ADDENDUM 1 NOTES:
1. LEACHATE COLLECTION SYSTEM NOTES ADDED

GEORGETOWN COUNTY
CLASS THREE LANDFILL CELLS 8-12 &
CLASS TWO LANDFILL CLOSURE PROJECT

CLASS THREE LANDFILL
TOP OF PROTECTIVE COVER GRADES
AND LEACHATE COLLECTION PIPING SYSTEM PLAN

SHEET 5

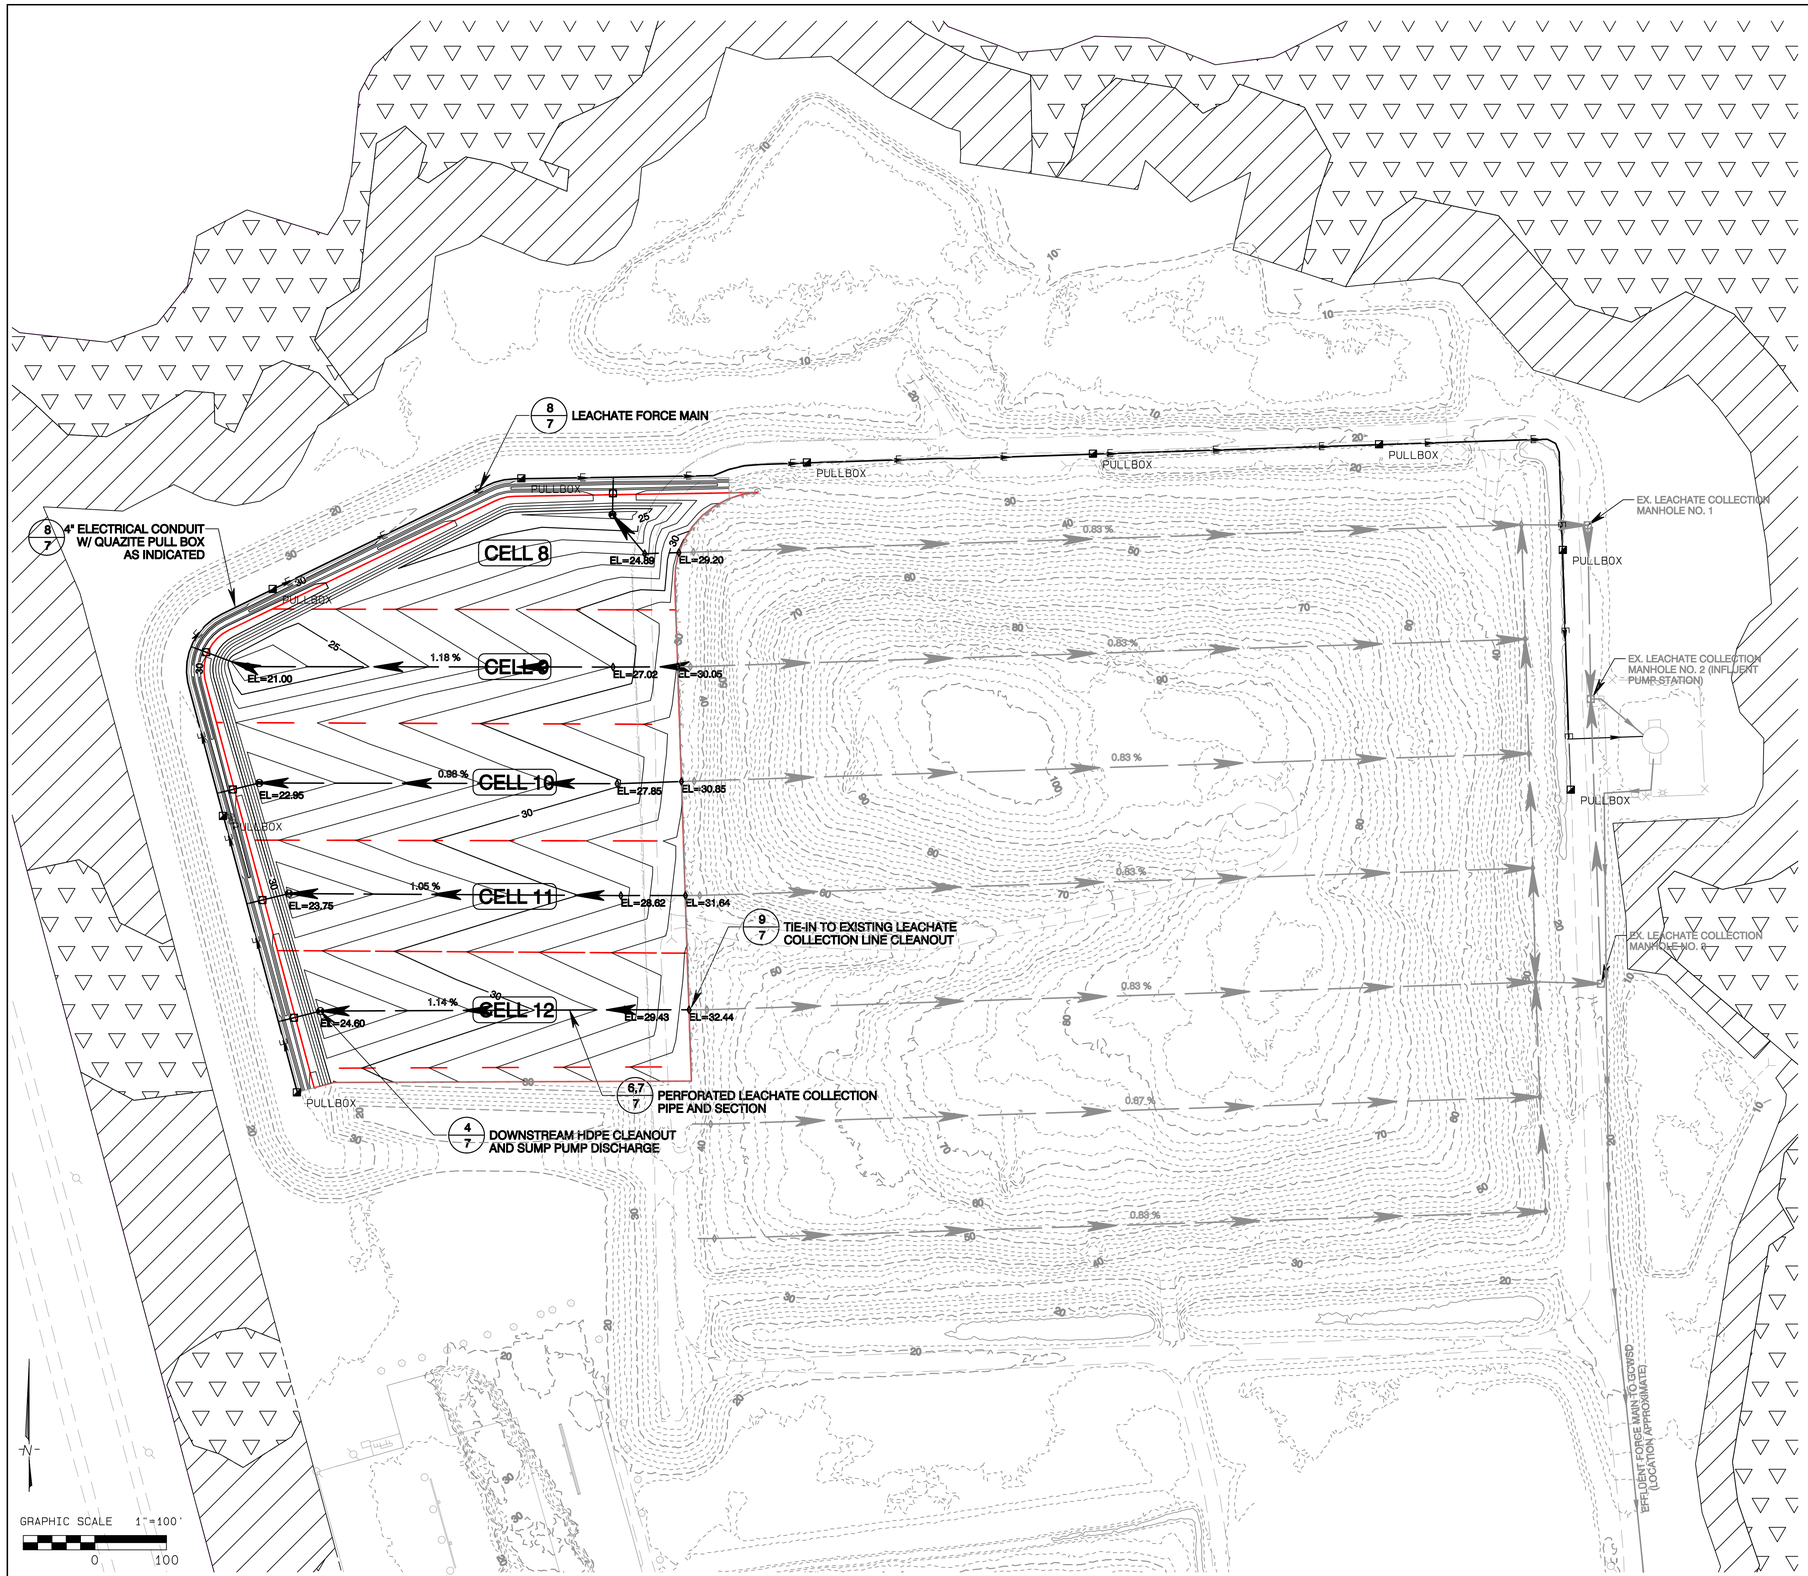
1. THE 8-FOOT HORIZONTAL SECTION OF THE 24-INCH SIDE SLOPE RISER PIPE SHALL BE PERFORATED PER DETAIL 7/7.
2. TERMINATE TO LEACHATE FORCE MAIN AT THE LEACHATE TANKS USING A 90-DEGREE BEND AND A BLIND FLANGE INSTALLED 2 FEET ABOVE EXISTING GRADE.
3. TERMINATE THE LEACHATE FORCE MAIN UPSTREAM OF CELL 12 USING A BLIND FLANGE.
